# ***Lower Duwamish Waterway Group***

## **MEMORANDUM**

Subject: Comments on the Snopac Property In-water Feasibility Study Report and Draft Uplands Cleanup Action Plan

Date: April 24, 2025

FIGURE NO.  
10

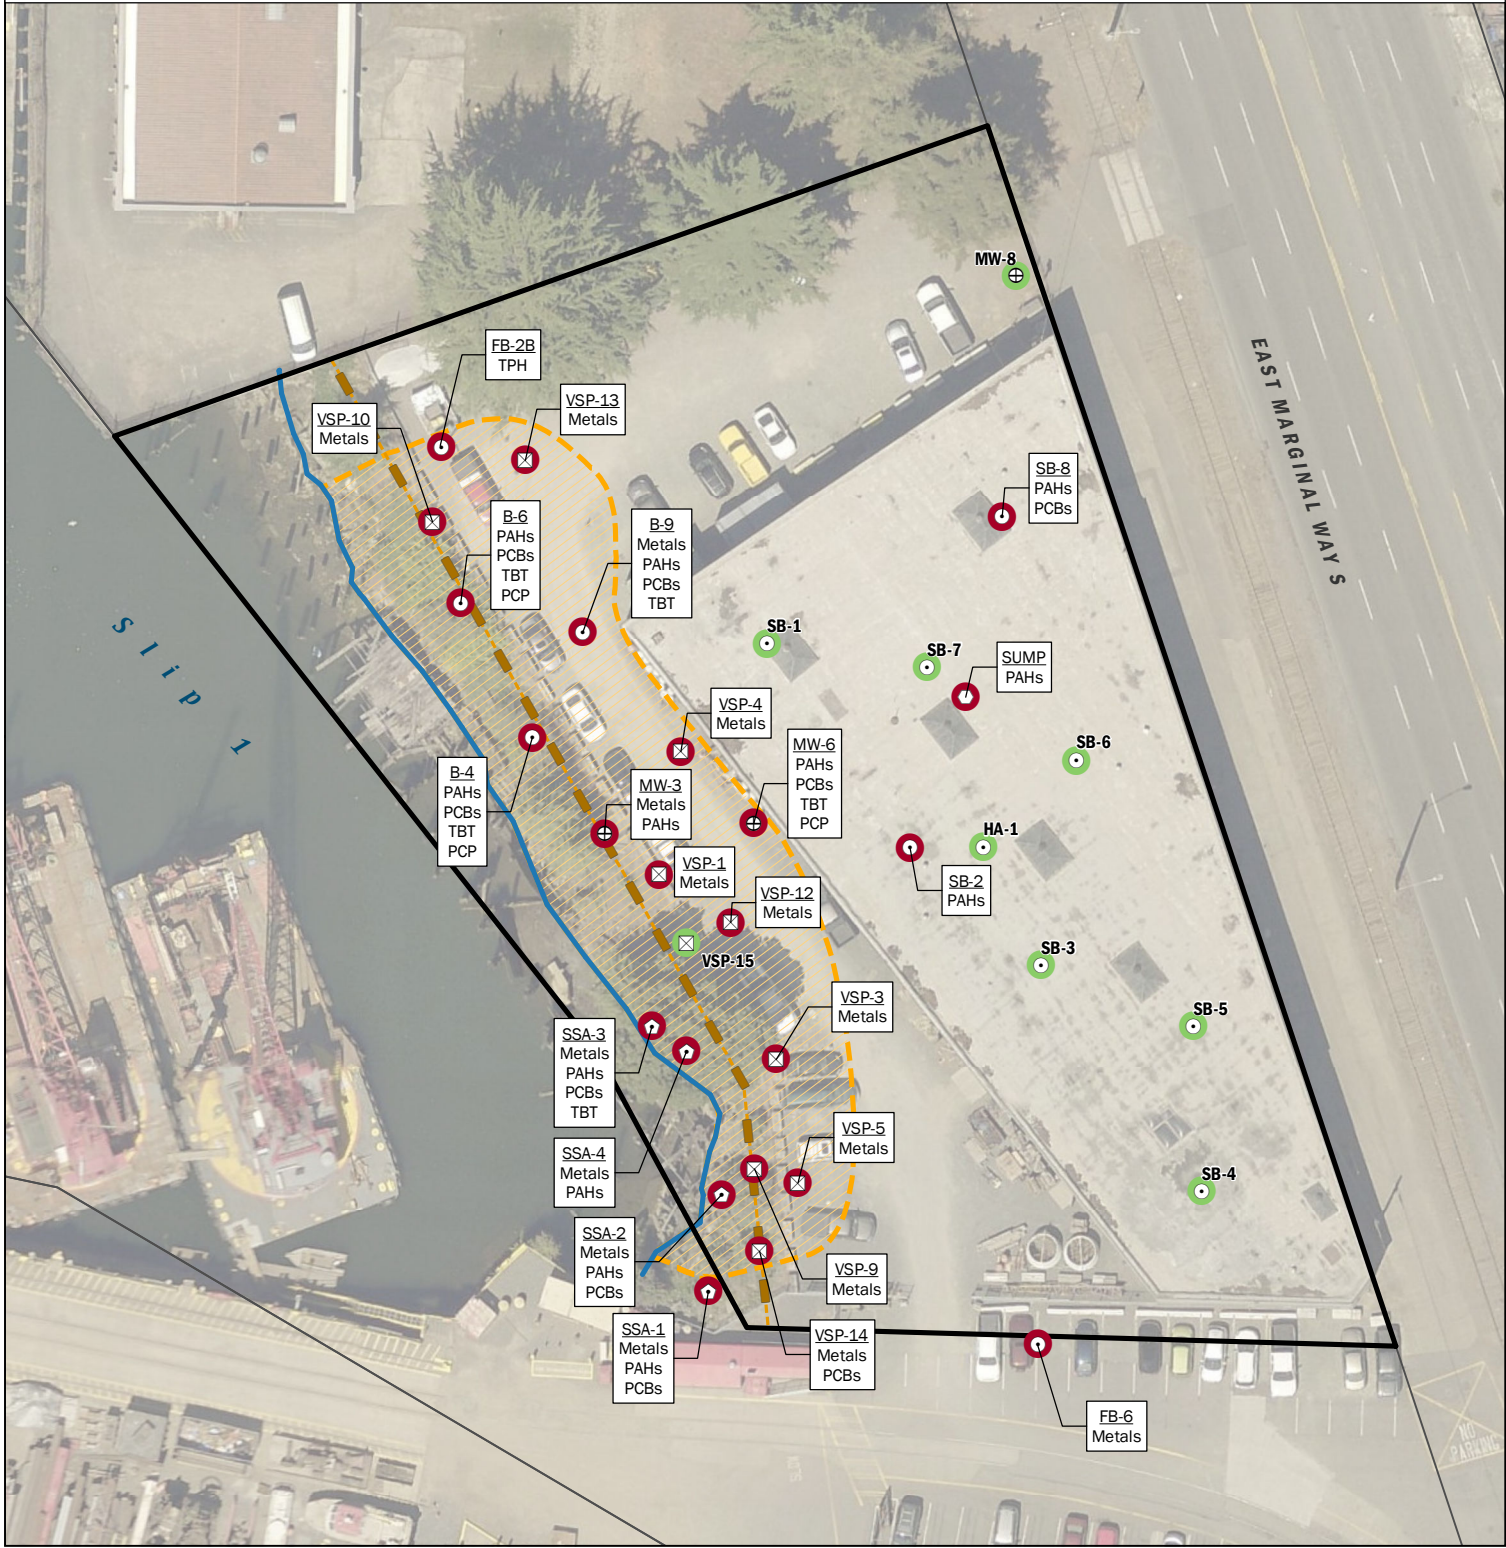
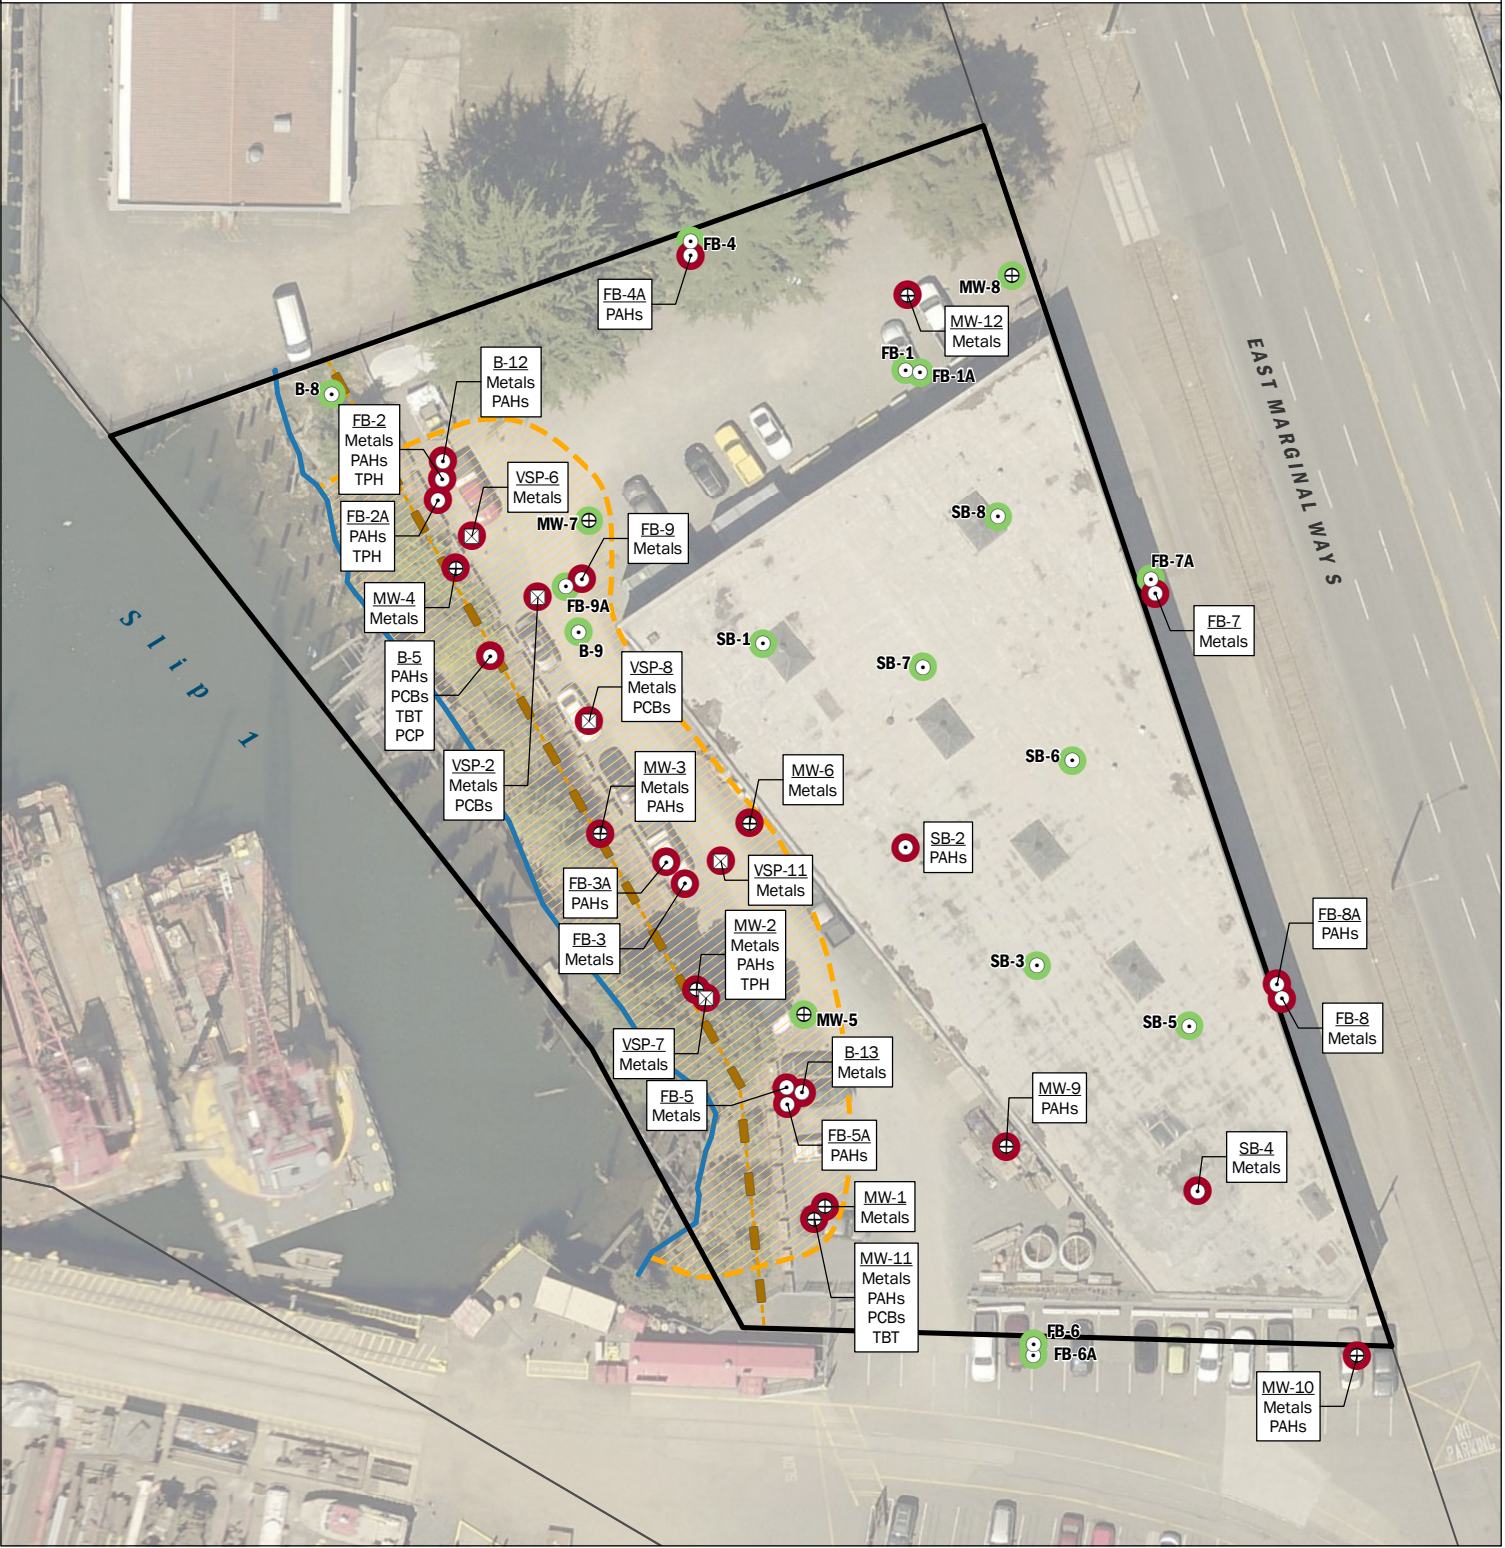
2. The bank containing sandblast grit clearly extends beneath the overwater structure associated with GSA and Federal CTR S. There is no characterization of the under-pier area, no discussion of whether the historic grit dumping might have extended past the property line and/or affected the bank/sediments under the structure. What is the plan for investigating this under-pier area for either grit disposal or transport?

The bank containing smelter slag-derived sandblast grit has already been thoroughly investigated and does not extend under the overwater structure associated with GSA and Federal CTR S. As a result, there are no plans for working in the under-pier area on the north side of the property.

- Arsenic and metals concentrations in northernmost soil boring B-8 soil were below the PCULs ([Figure 10 and Table 2 of the RI<sup>1</sup>](#)).
- Removal of SBG-containing fill was confirmed both by visual observations in the interim action excavation and by collecting excavation sidewall and base samples following excavation south of B-8. Sidewall and base samples, near the northern site boundary, had metals concentrations below the upland remediation levels, indicating that SBG-containing fill has been removed and SBG impacts do not extend north to the property boundary ([Table 2A and Figure 2 of Interim Action Report; Aspect 2021<sup>2</sup>](#)).
